2012 Central Valley Flood Protection Plan

Public Draft | December 2011

Errata Sheet

Figure 2-3 “Improvements Included in Enhance Flood System Capacity Approach” is replaced by the correct version in the following page.

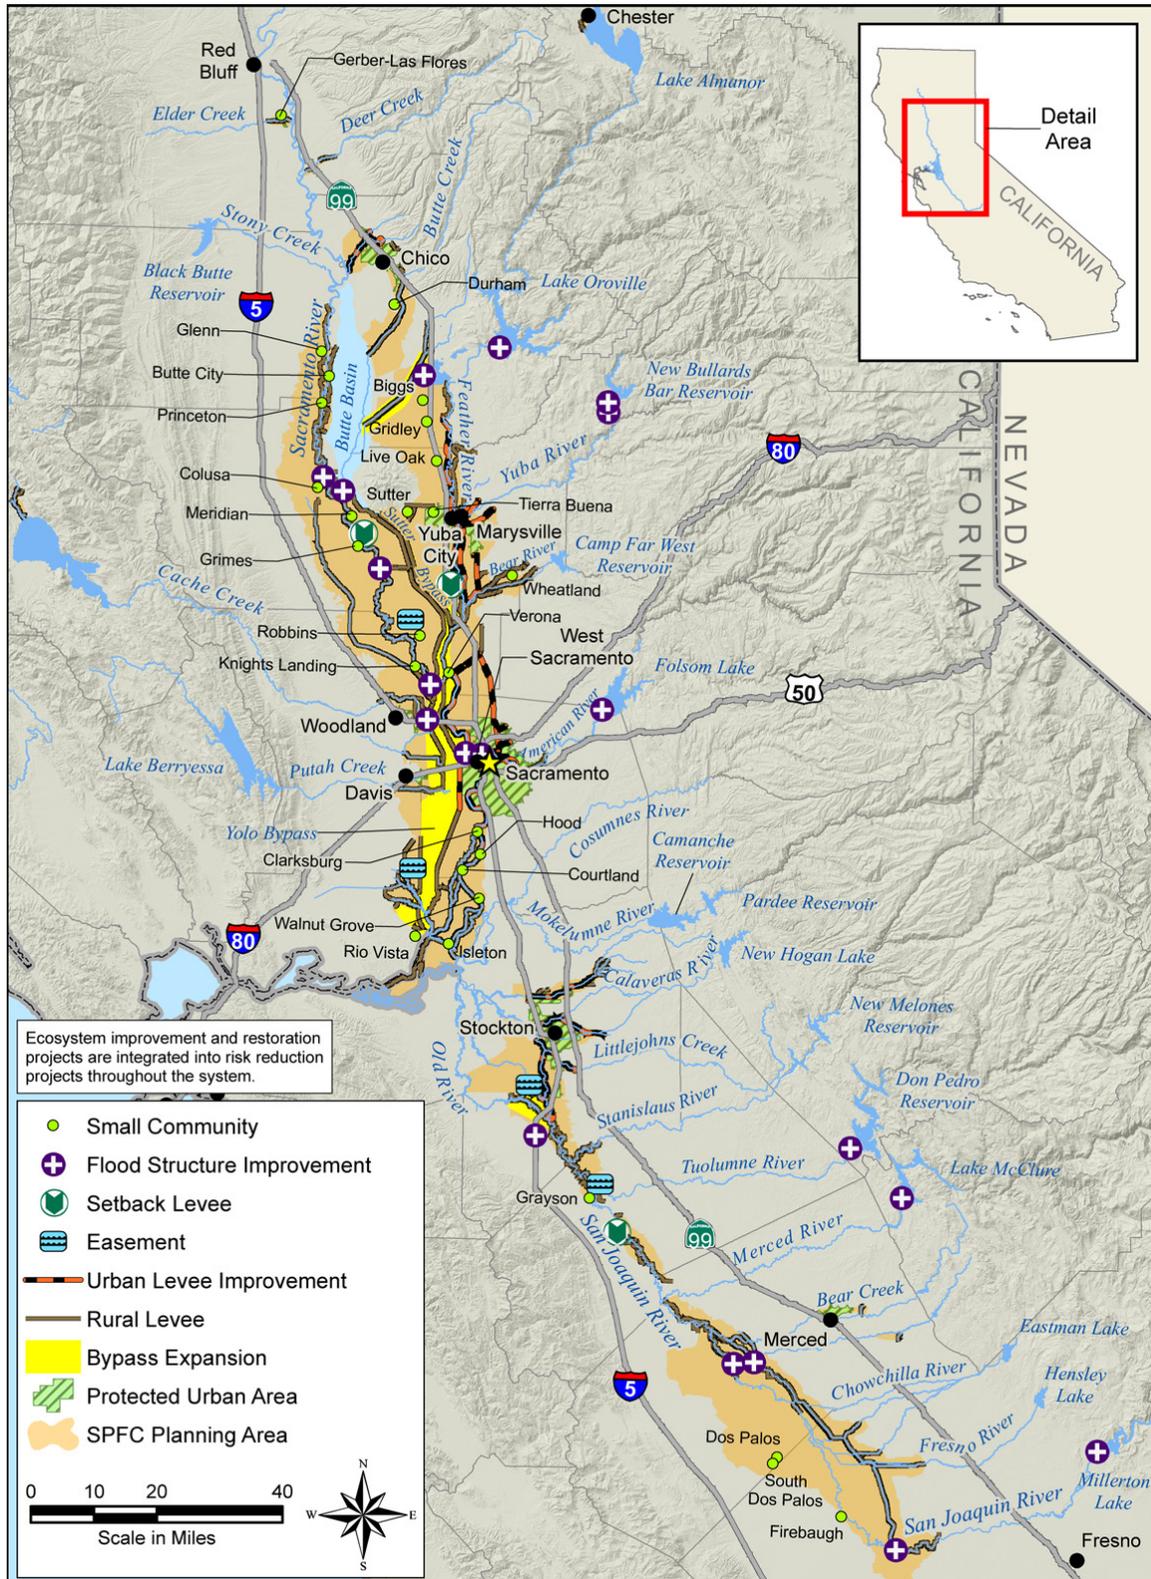
4. Section 2.5.1, Page 2-11
